## HISTORIC AND DESIGN REVIEW COMMISSION

December 20, 2017

**HDRC CASE NO:** 2017-647  
**ADDRESS:** 114 CAMARGO  
**LEGAL DESCRIPTION:** NCB 923 BLK 4 LOT W 5.6 FT OF 3 & E 28 FT OF 2  
**ZONING:** RM-4 H  
**CITY COUNCIL DIST.:** 1  
**DISTRICT:** Lavaca Historic District  
**APPLICANT:** Grace Boudewyns  
**OWNER:** Elizabeth Longoria  
**TYPE OF WORK:** Rehabilitation including fenestration changes  
**APPLICATION RECEIVED:** December 01, 2017  
**60-DAY REVIEW:** February 01, 2018

**2** EXISTING SITE PLAN  
SCALE: 1/16" = 1'-0"

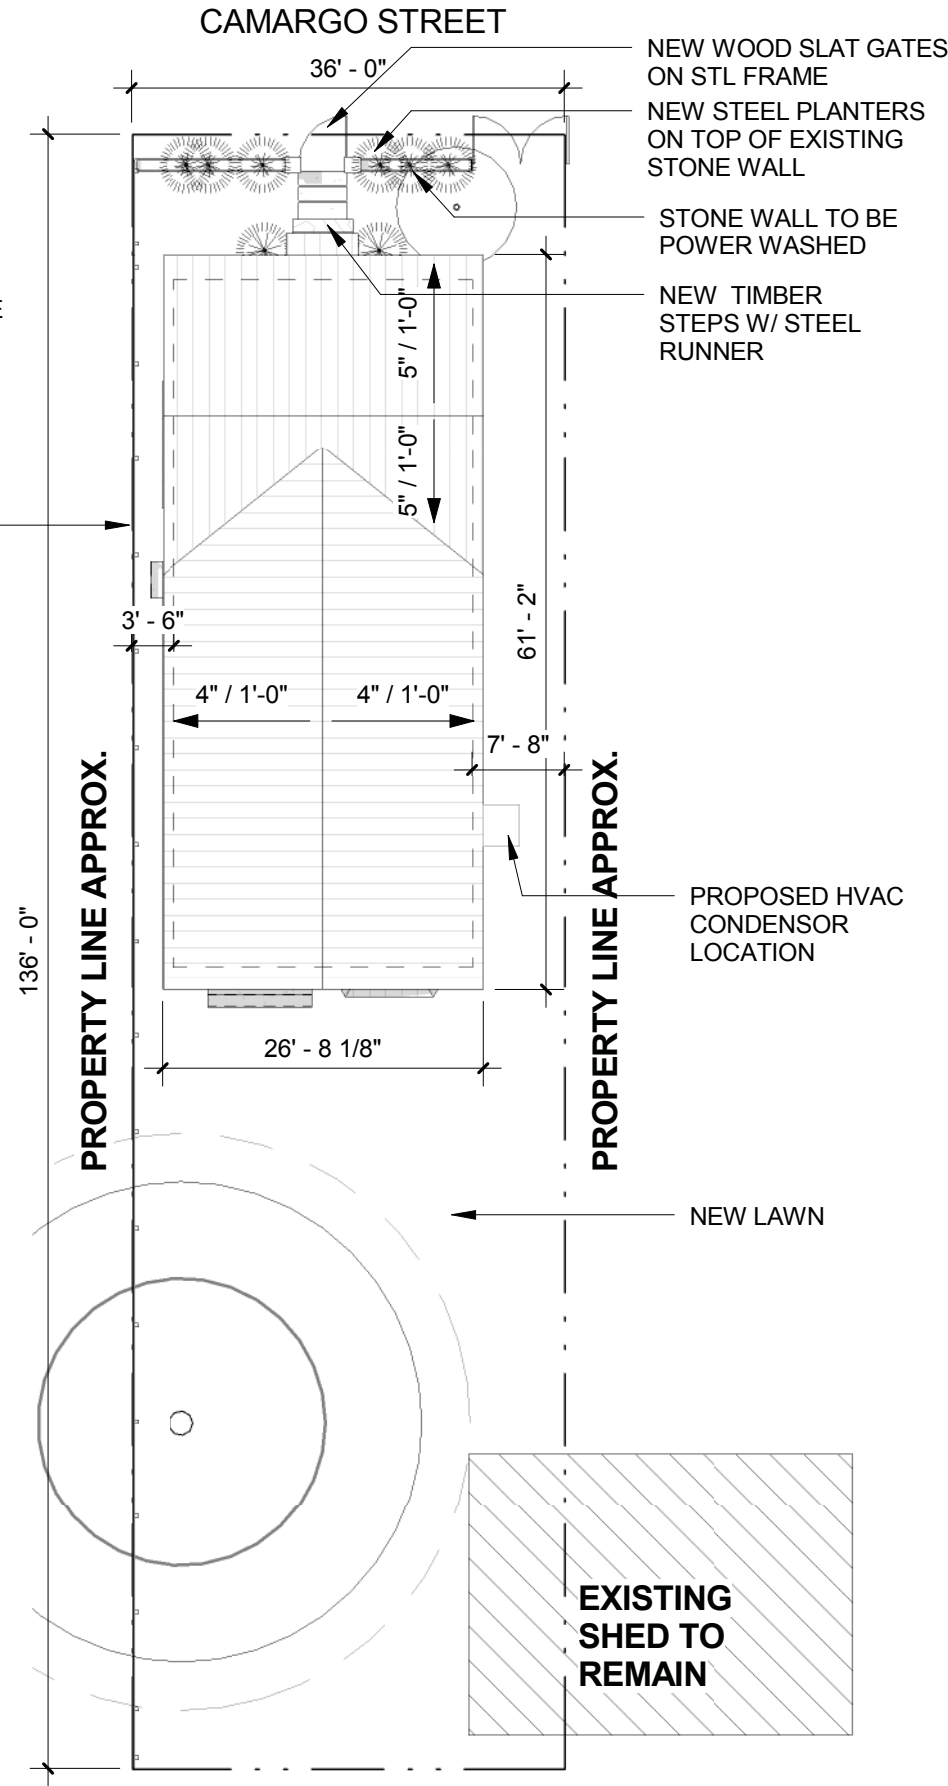
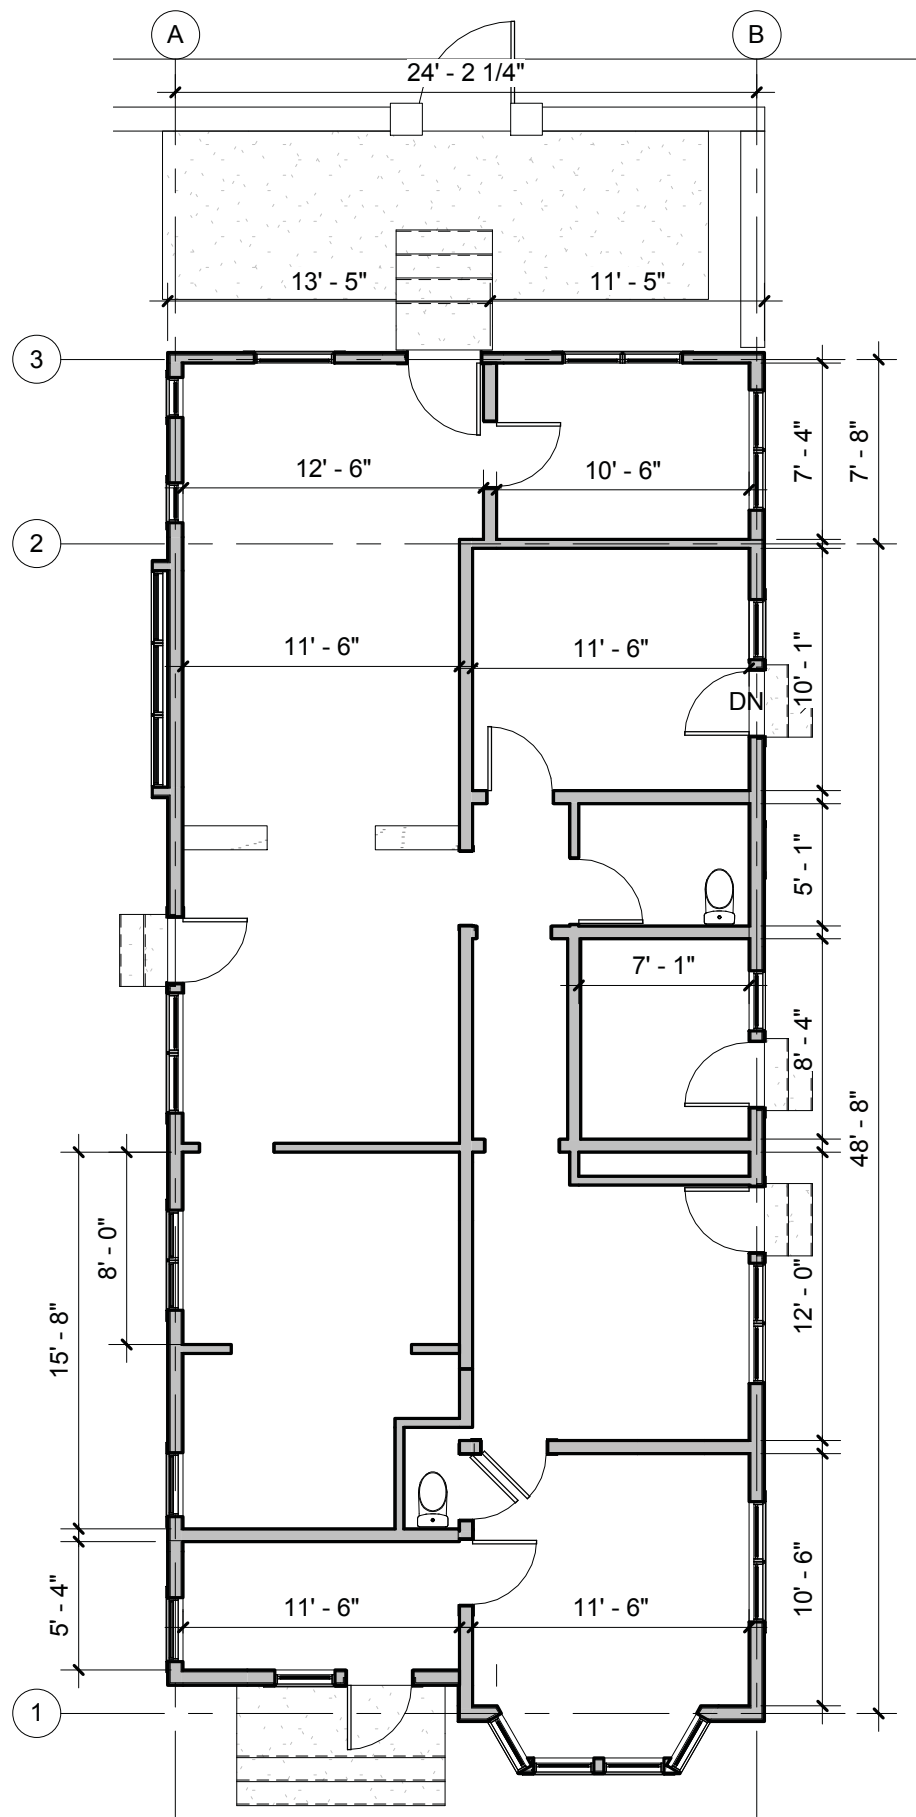
- f. **SITE ELEMENTS** – The applicant has proposed to remove the existing railing on the front stone wall to install planters. Staff finds the removal of the wrought iron railing is appropriate given that they are not original to the structure. However, per the Guidelines for Fences and Walls 2.B.iii, front yard walls are limited to four feet in height. Staff finds that the installation of planters would create a solid wall that exceeds four feet and therefore is not consistent with the Guidelines.

- g. **STONE WALL** – The applicant has proposed to demolish the side stone wall between the front yard and the driveway. Staff finds that the stone wall is not historic and its removal does not negatively impact the historic structure.

- iii. Staff recommends approval of the removal of non-historic shutters.
- iv. Staff recommends the replacement of stucco skirting with wood.
- v. Staff recommends approval to remove the wrought iron railing. Staff does not recommend the installation of planters.

- vi. Staff recommends the removal of the stone wall between the front yard and the driveway.

## EXISTING ELEV. - NORTH

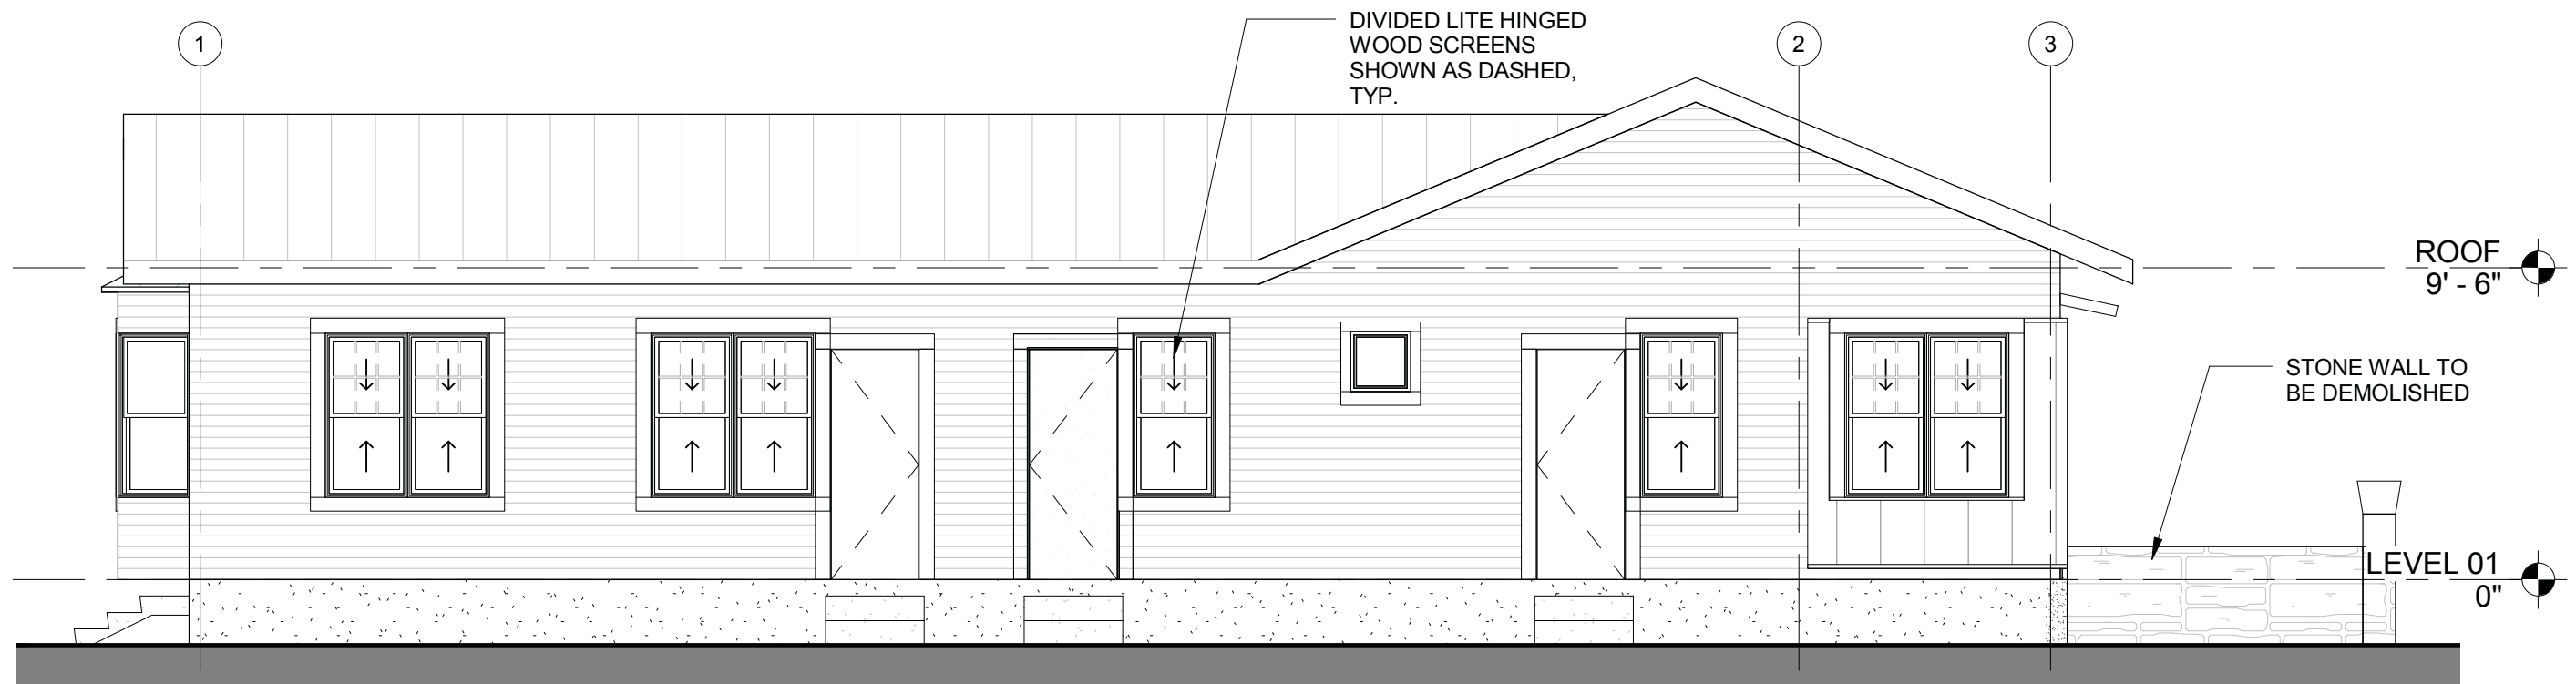
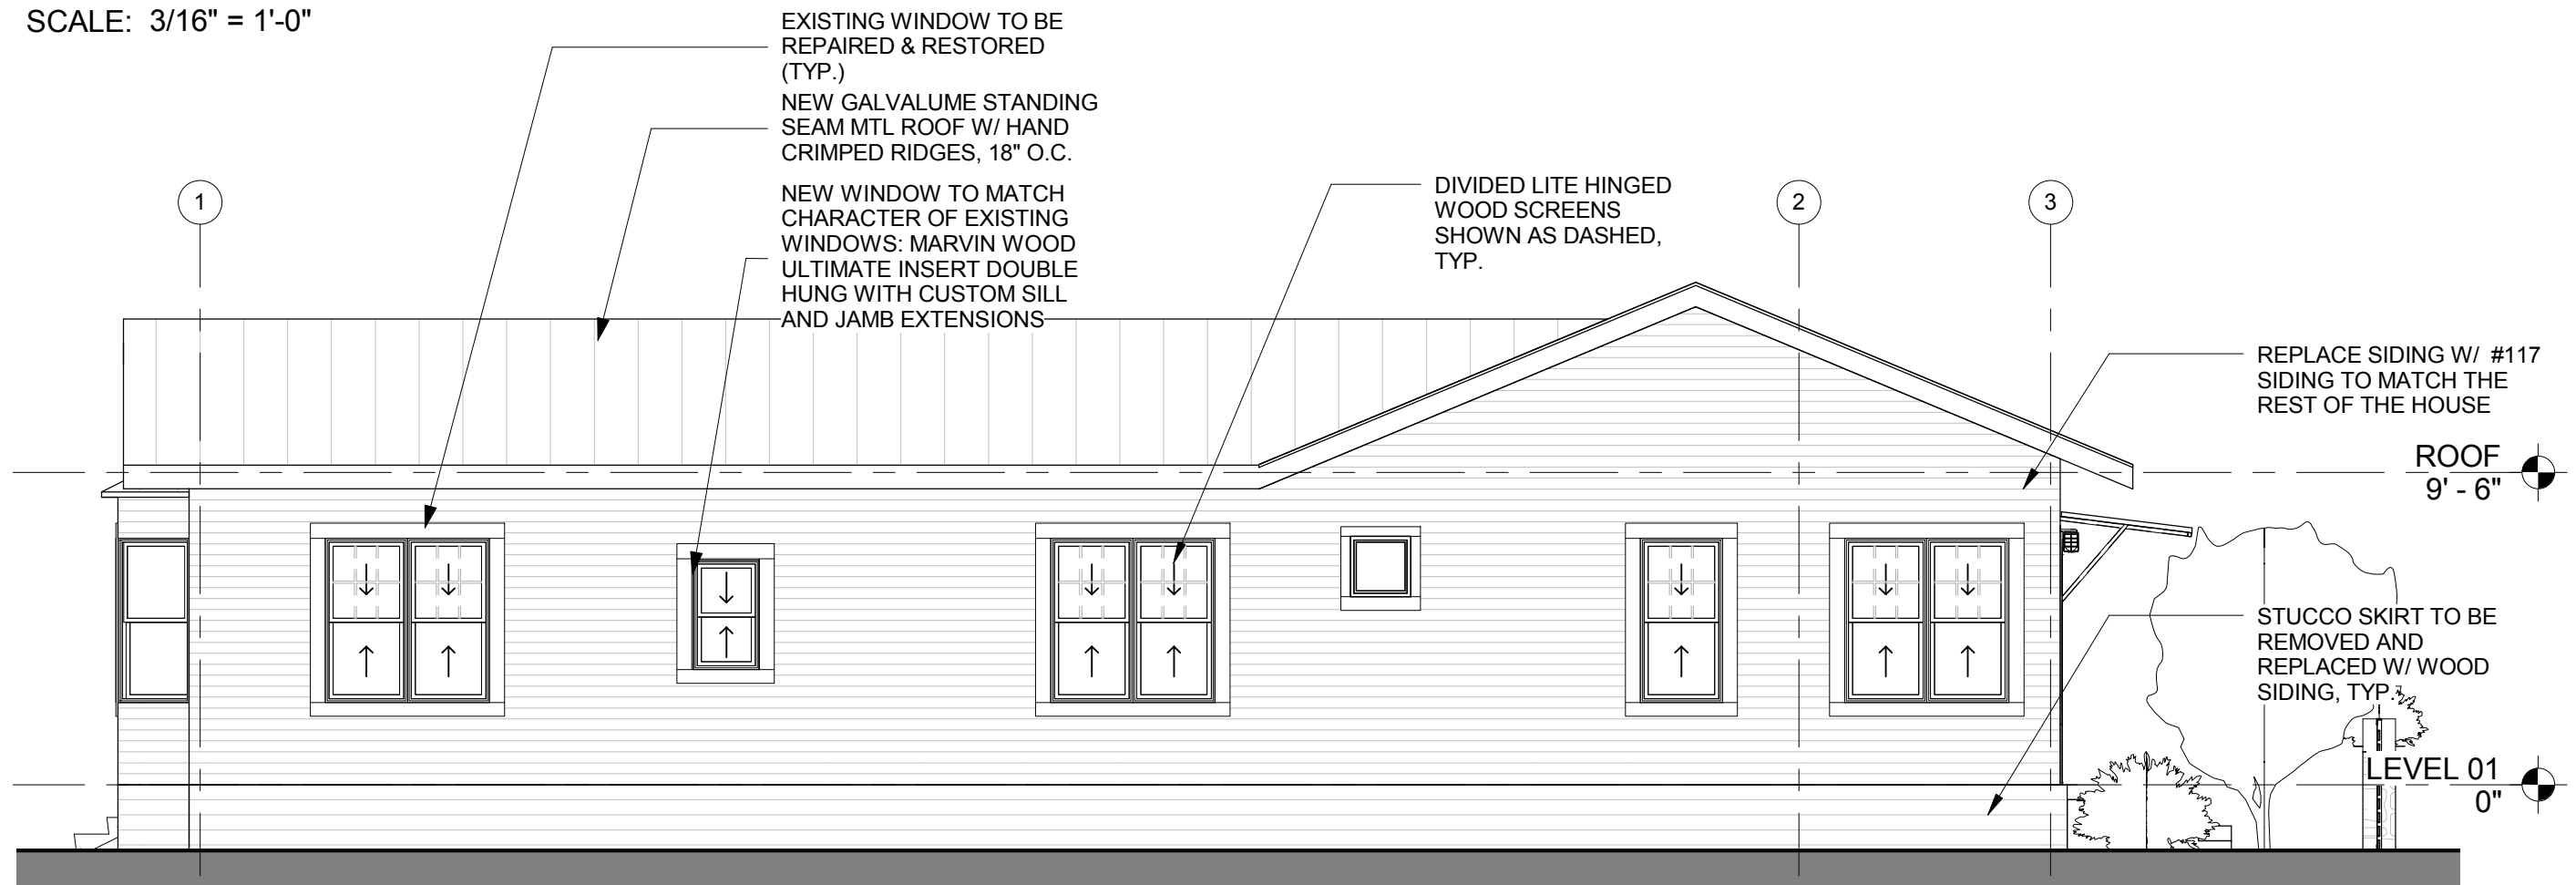
- b. WINDOWS/DOOR – The applicant has proposed to restore all facades to their original configuration. This request items include: (1) removing the double windows on the left of the front façade to install a window that matches the existing right side window, (2) removing three side doors and relocating three windows on the east elevation, (3) removing rear window to install double door to rear steps, (4) removing three non-historic square windows and reinstalling rear window to east elevation. All proposed window changes will feature salvaged windows relocated from the property or double-hung wood windows with a matching profile. Staff finds the proposed fenestration changes are consistent with the Guidelines for Maintenance and Preservation of Architectural Features 6.A.i through 6.B.x., provided that the following specifications are met: the proposed windows should feature meeting rails that are no taller than 1.25” and stiles no wider than 2.25”. There should be a minimum of two inches in depth between the front face of the window trim and the front face of the top window sash which will allow for the installation of an appropriate wood screen. This must be accomplished by recessing the window sufficiently within the opening or with the installation of additional window trim to add thickness. Window trim must feature traditional dimensions and an architecturally appropriate sill detail. Window track components must be painted to match the window trim or concealed by a wood window screen set within the opening.

- c. FRONT AWNING – The applicant has proposed to remove the existing non-historic awning over the front door to replace it with a metal framed awning with a low pitched standing seam metal roof. Per the Guidelines for Canopies and Awnings 11.B.ii, new awnings should be based on the architectural style of the building and be proportionate in shape and size to the scale of the building façade. Staff finds the proposed awning generally appropriate if the awning featured wood framing rather than metal.

- d. SHUTTERS/DECORATION – The applicant has proposed to remove front decorative shutters. Given that the shutters were added when the front porch was enclosed, staff finds the removal of front shutters appropriate.

- i. Staff recommends approval of the façade and elevation restoration including the installation of new wood windows and the relocation of salvaged windows from the structure with the stipulation that they are consistent with Guideline’s specifications noted in finding b: the proposed windows should feature meeting rails that are no taller than 1.25” and stiles no wider than 2.25”. There should be a minimum of two inches in depth between the front face of the window trim and the front face of the top window sash which will allow for the installation of an appropriate wood screen. This must be accomplished by recessing the window sufficiently within the opening or with the installation of additional window trim to add thickness. Window trim must feature traditional dimensions and an architecturally appropriate sill detail. Window track components must be painted to match the window trim or concealed by a wood window screen set within the opening.

- ii. Staff recommends approval of the front porch awning replacement with the stipulation that the framing material feature wood framing rather than metal.
